Detailed Site Plan

DSP-18049

Walker Mill Road Business Park

STAFF REPORT

Figure 1: Proposed Architectural Elevations

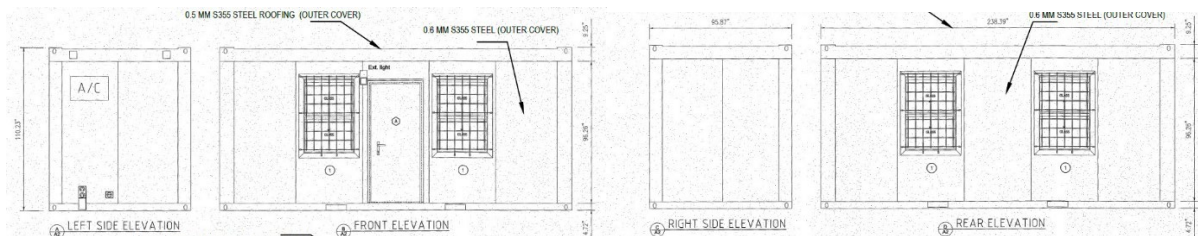
The applicant has proposed a one-story, 160-square-foot, trailer office with a flat roofline that is approximately 9 feet in height. The use of durable, quality materials is proposed on the building and includes steel siding and glass, with an entrance proposed on the front building face. The front and rear elevations are accented by two windows that break up the horizontal face of the building. The side elevations present uninterrupted façades, with no architectural treatments, and continue the steel siding proposed on the front and rear of the building.

Staff recommends additional site and architectural improvements to screen and enhance the appearance of the building from the public right-of-way. Additional treatments include painting the exterior of the building in a neutral color to provide a clean and contemporary finish to the building; installing a skirt at the base of the building to screen the wheels and undercarriage of the structure, in a material and color that will complement the façade of the building; and constructing a minimum 10-foot by 10-foot curbed landscaped island on the southwest side of the building, planted with one shade tree, to screen the building from Walker Mill Road. Conditions are included herein requiring these modifications.

- c. Indicate that the proposed trailer office will be painted a neutral color on all sides and provide a skirt, in a similar material and color, around the entire base to screen the wheels and undercarriage of the structure.

Figure 2: Cross Section of Proposed Storage Yard

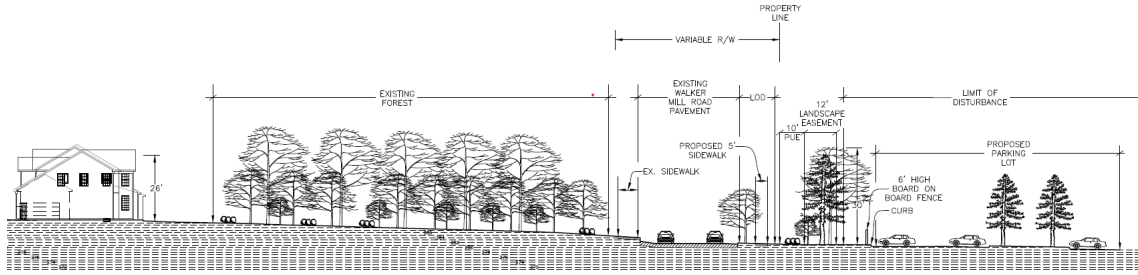
- C. Provide cross-sections through the subject site to demonstrate that any area of outdoor storage visible from any adjacent right-of-way shall have the solid wood fence specified in condition 1. a.**

A 6-foot-high wooden fence is proposed along the perimeter of the subject property, and the appropriate landscaping is proposed along Walker Mill Road, in accordance with this condition. In addition, the cross-section exhibit submitted with the DSP demonstrates that the outdoor storage area will be sufficiently screened from the public right-of-way.

SITE PLAN

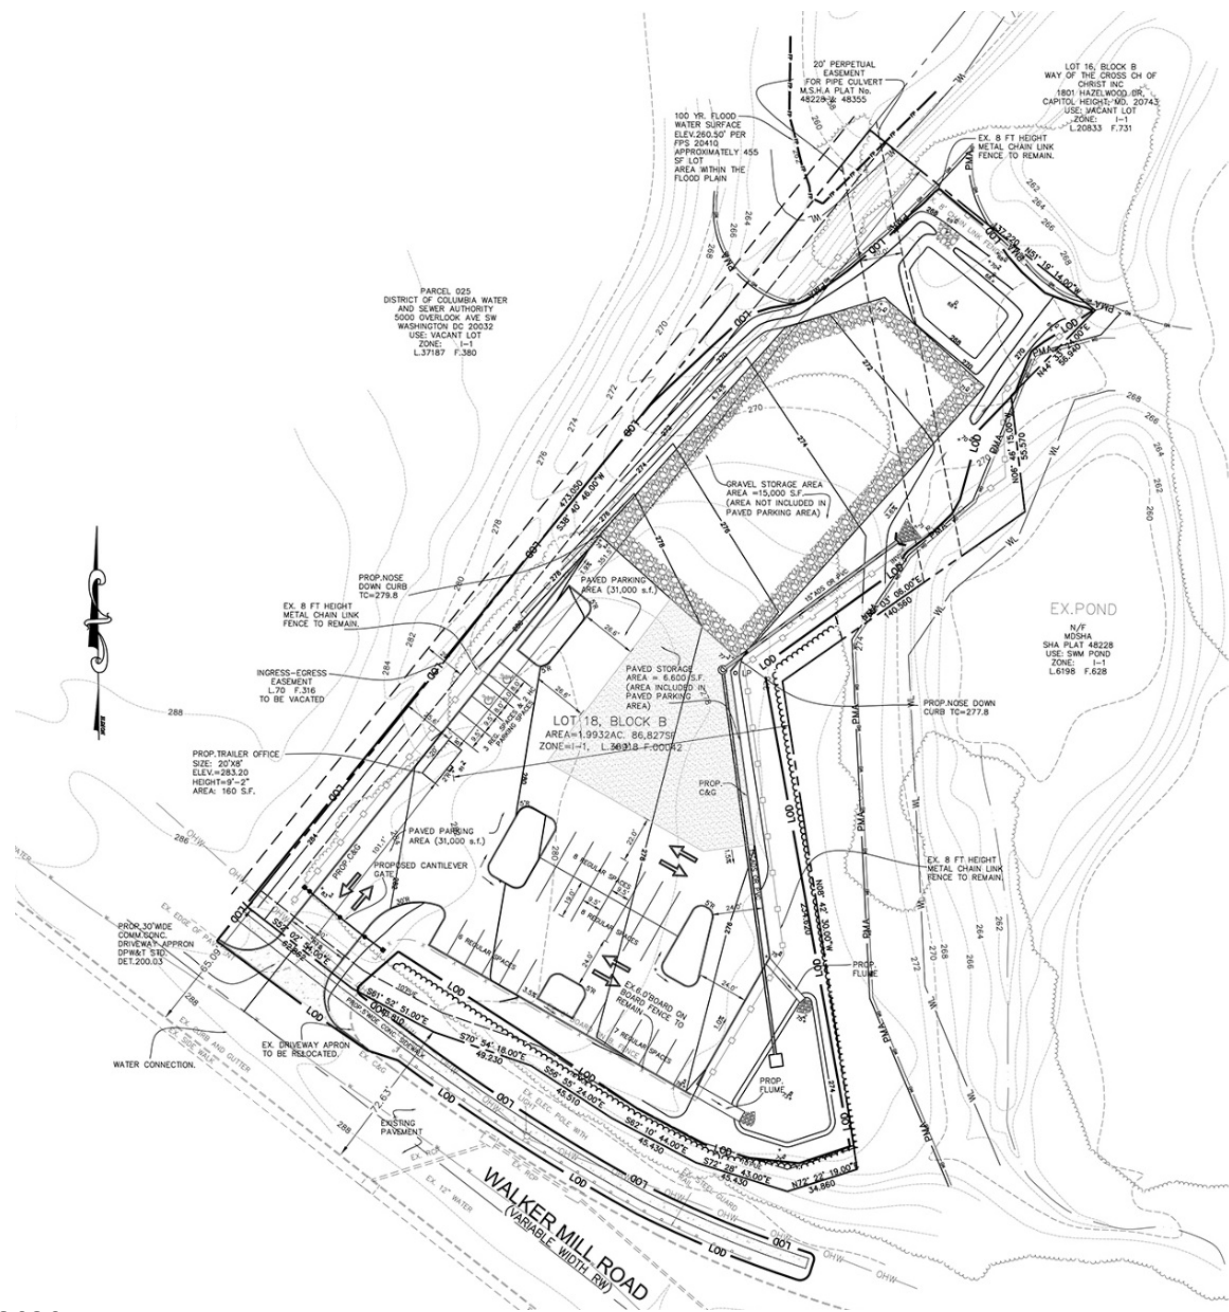
Notes: *Staff notes that the parking and loading schedule shown in the general notes does not clearly list the number of proposed and required loading spaces. The schedule should be revised to clearly list the loading requirements, as conditioned herein.

- d. Provide an additional minimum 10- by 10-foot curbed landscape island on the southwest side of the building, planted with one shade tree, to screen the building further from Walker Mill Road.

- e. Revise the parking and loading schedule to clearly show the required and proposed loading spaces for the use, demonstrating conformance to Sections 27-578 and 27-582 of the Prince George's County Zoning Ordinance.
